**OHIO TURNPIKE AND  
INFRASTRUCTURE COMMISSION**

**ADDENDUM NO. 3**  
**ISSUED APRIL 23, 2020**

**PROJECT NO. 70-20-01 (RE-BID)**  
**SLOPE REPAIRS**  
**MILEPOST 132.6 WB**  
**LORAIN COUNTY, OHIO**

**ATTENTION OF BIDDERS IS DIRECTED TO:**  
**ANSWERS TO QUESTIONS RECEIVED THROUGH 8:00 A.M. ON APRIL 23, 2020**

MP132.6 Reinforced Embankment Quantity Calculations

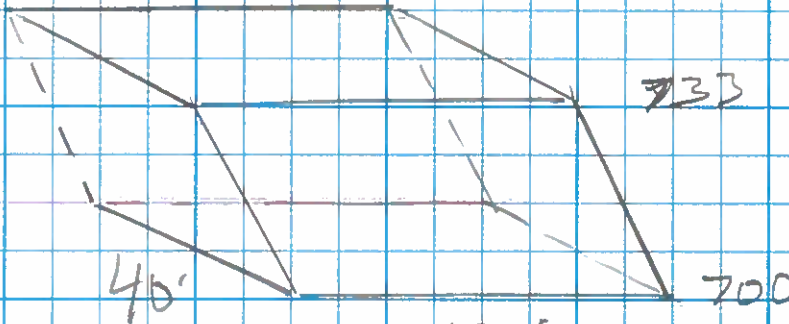
**Q#7** Cross section sheets 17-20 give quantities for excavation and embankment. However there are no calculations or takeoffs for bid items 9, 10, and 11. Please provide calculations and or takeoffs as to how these three bid items were calculated.

*A#7 Attached are the Engineer's estimates for these Bid Items. These quantity calculations are being provided, but shall be considered for reference only.*

GEOGRID

BEHIND HEADWALL

$18 / 2.5 = 7.2$   
 USE 8  
 LAYERS  
 GEOGRID

$$(40)(96-45)(8) = 16,320$$

$$(29)(45)(8) = 10,440$$

$$\text{TOTAL} = 26,760 = \underline{2973 \text{ SY}}$$

ABOVE HEADWALL

$33 / 2.5 = 13.2$   
 USE 14  
 LAYERS  
 GEOGRID

$$(40)(180)(14) = 100,800 \text{ SF} = \underline{11,200 \text{ SY}}$$

GRANULAR EMBANKMENT

BEHIND HW

$$(40)(18)(96-45) / 27 = 1360 \text{ CY}$$

$$(29)(18)(45) / 27 = 870 \text{ CY}$$

$$\text{TOTAL} = \underline{2230 \text{ CY}}$$

ABOVE HW

$$(733-700)(40)(180) / 27 = \underline{8800 \text{ CY}}$$
